APPEAL SUMMARY

Appeal ID: 27754

Project Address: 550 SE MLK Jr Blvd

LUR or Permit Application No.: 21-084383-CO

33 EAST-WEST BUILDING SECTION LOOKING NORTH

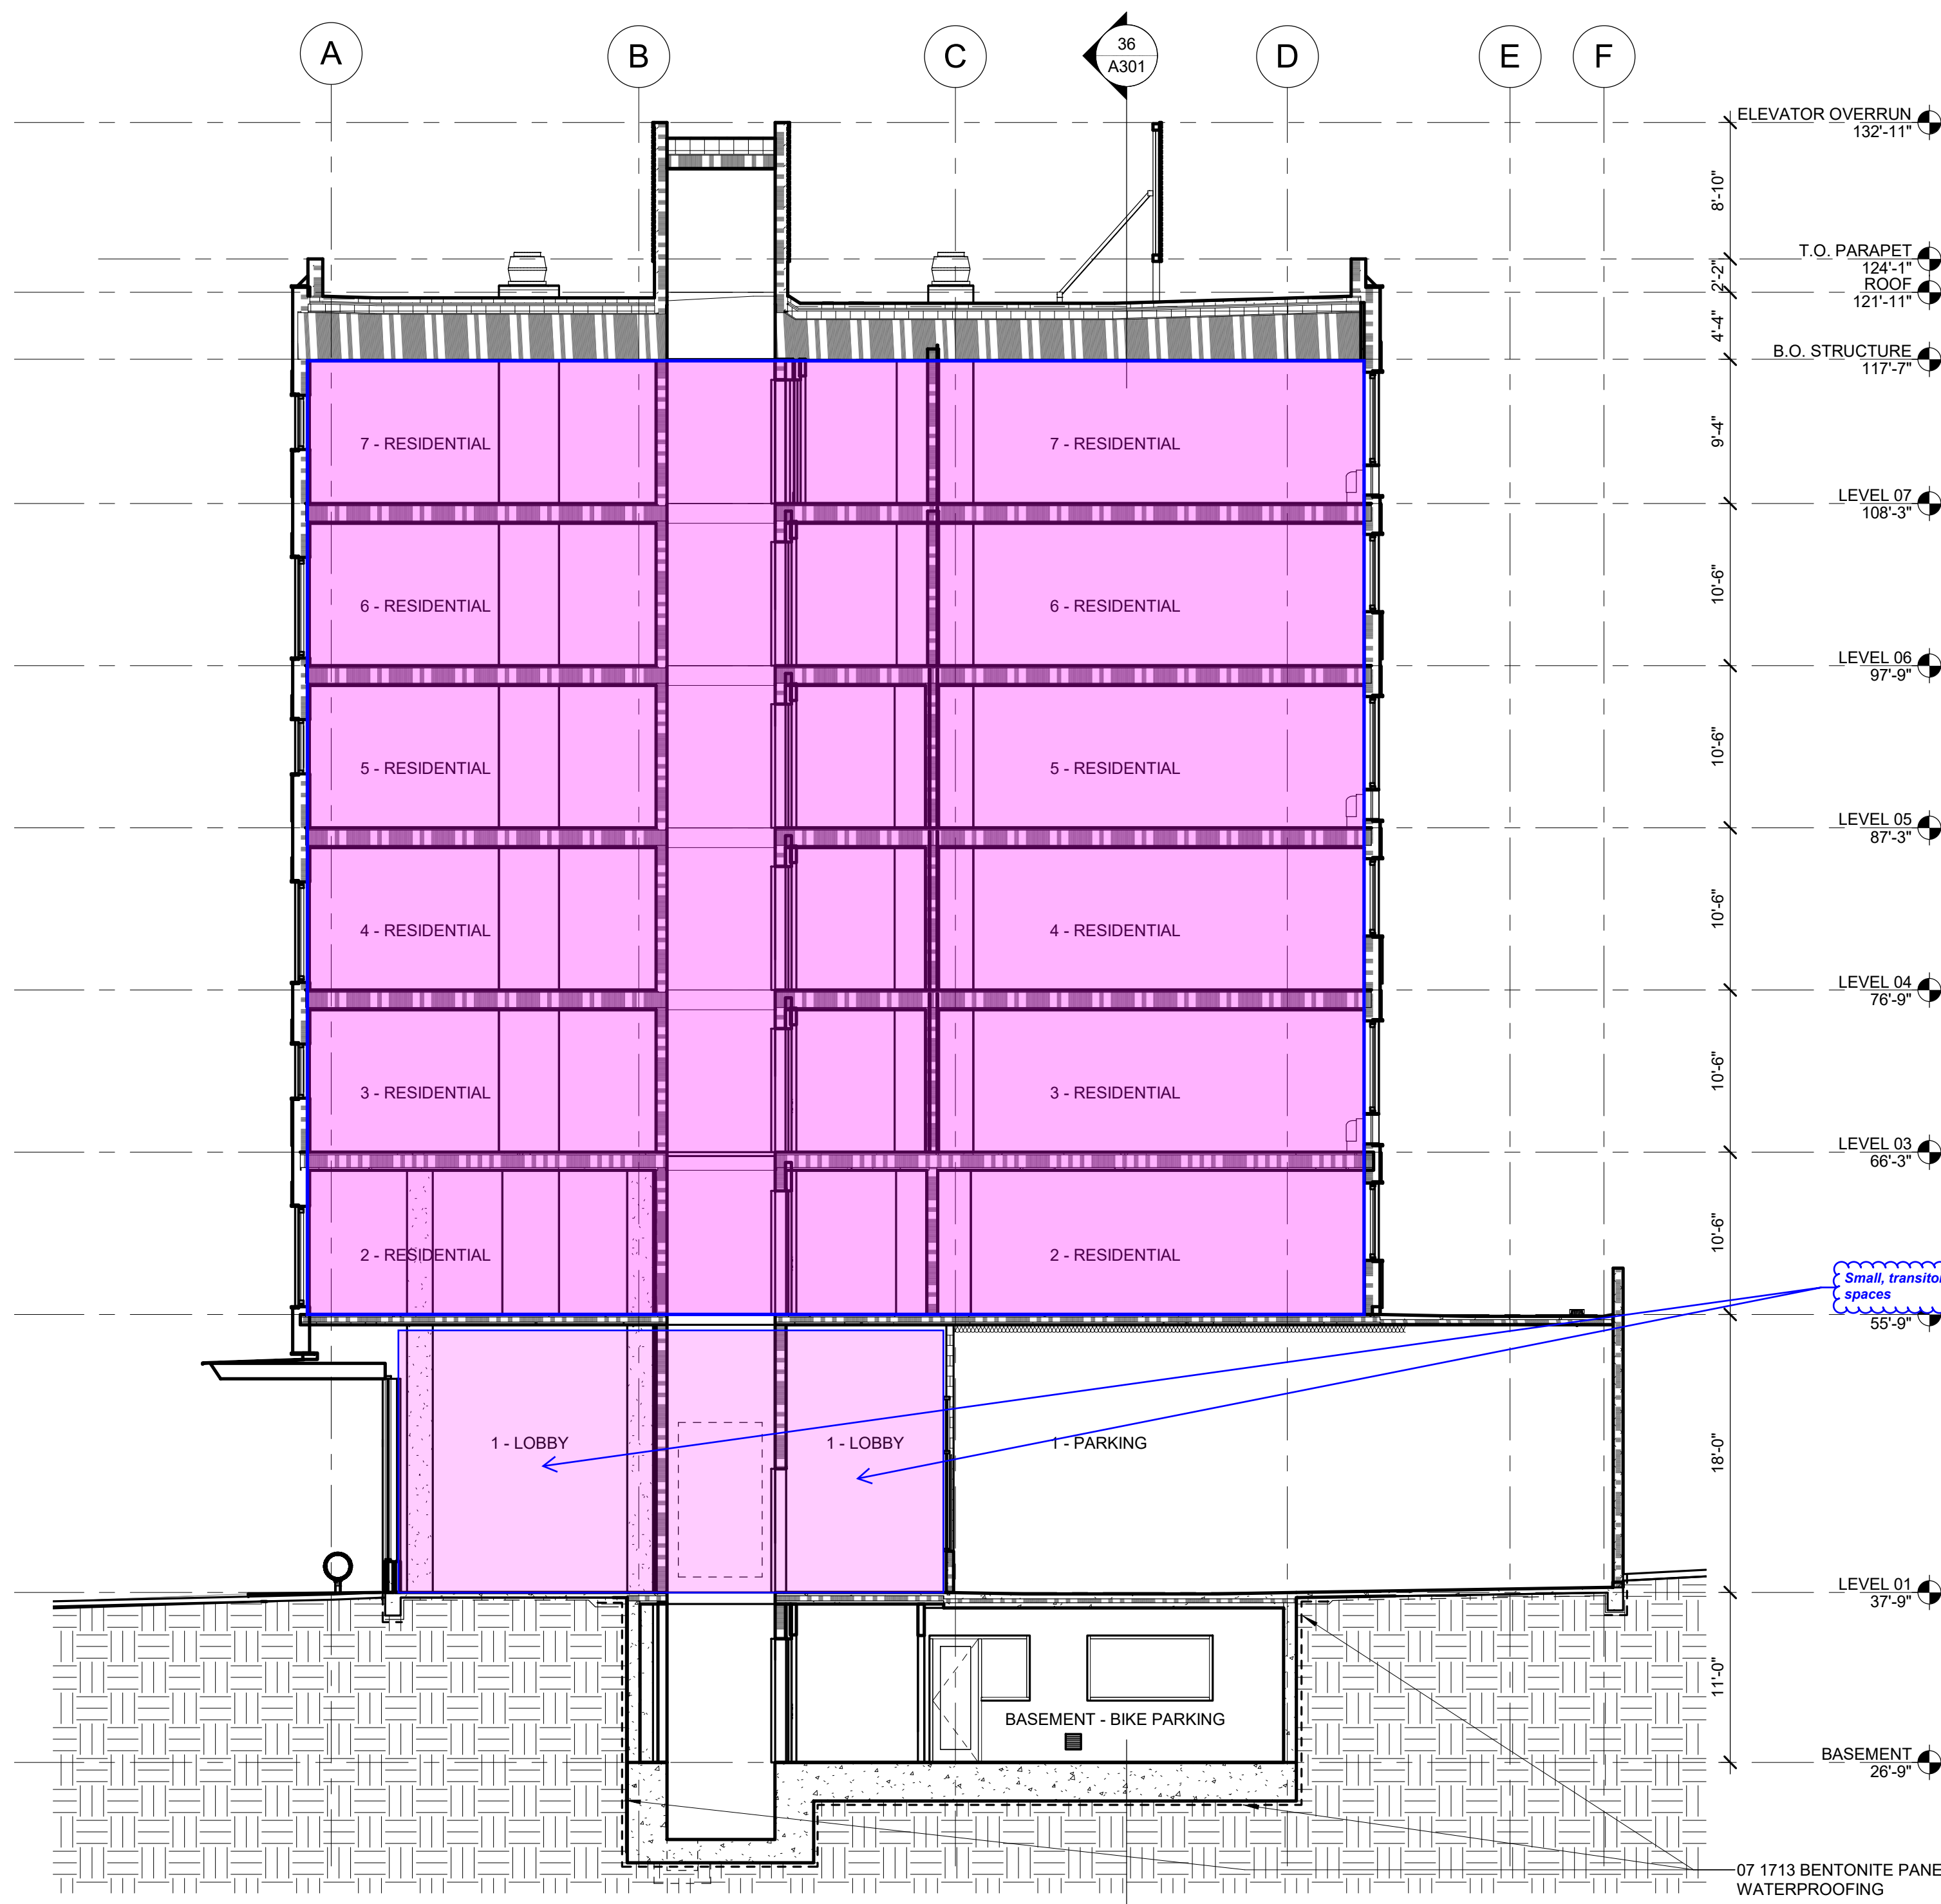
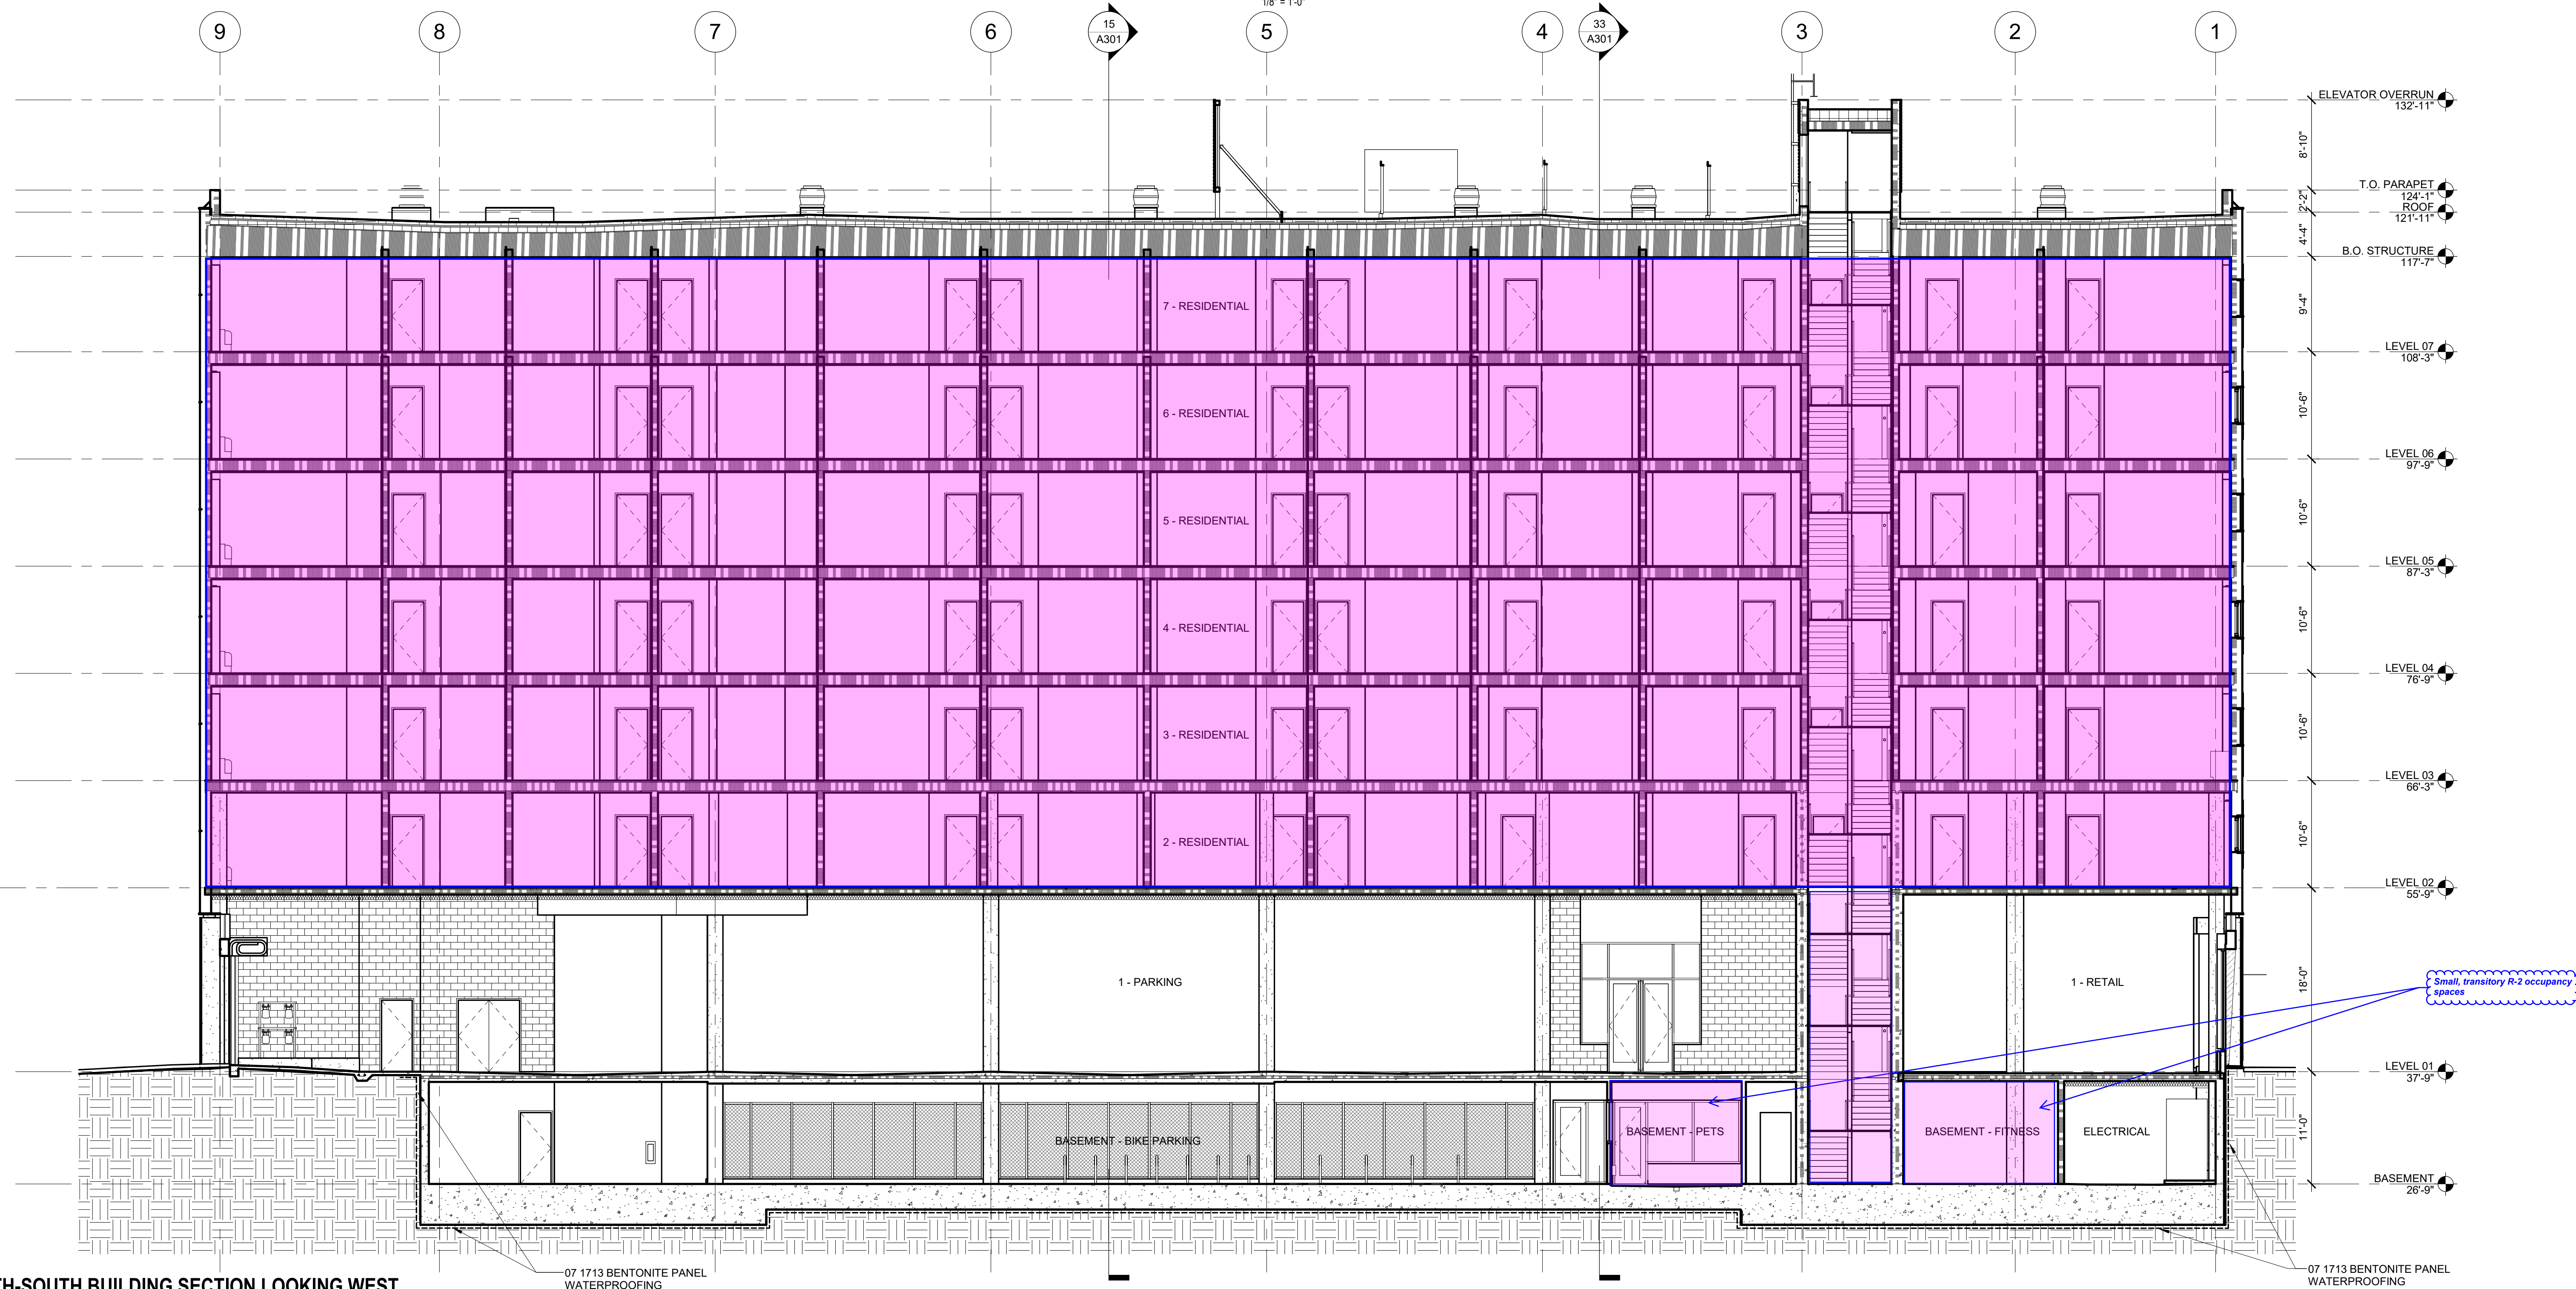
Please see attached building section A301 showing residential use location highlighted in the upper levels.

The Maker Space at Level 1 is used for short term/transient, miscellaneous craft and creative uses by residents; as such it has been re-categorized as a B occupancy, the closest applicable occupancy for this small space (567 sf). See updated Code Plan G100. The remaining normally occupied R-2 spaces at the basement and Level 1 (Lobby, Elevator Lobby, Mail, Refreshment Station, Fitness, Pet Relief) are only occupied occasionally for short periods of time; the occupancy in those spaces is transient in nature. These spaces are ventilated with fresh air according to the mechanical code. The small basement pet relief and fitness spaces receive higher rates of ventilation than is required, and are also short term/transient occupancies. The stairs are a very small footprint and also have very transient occupancy. These factors effectively make the need for radon mitigation unnecessary. The upper level non-transient R-2 occupancies are protected by this cushion of ventilated space at Level 1 and Basement. See updated G100 plan showing occupancy revision at Maker Space (now B), and A301 with the small short term/transient R-2 spaces at Level 1 and Basement highlighted.

Omission of radon mitigation at ground floor slabs: Granted provided the HVAC system in the in the common areas don't intermix with the HVAC system in the residential areas.
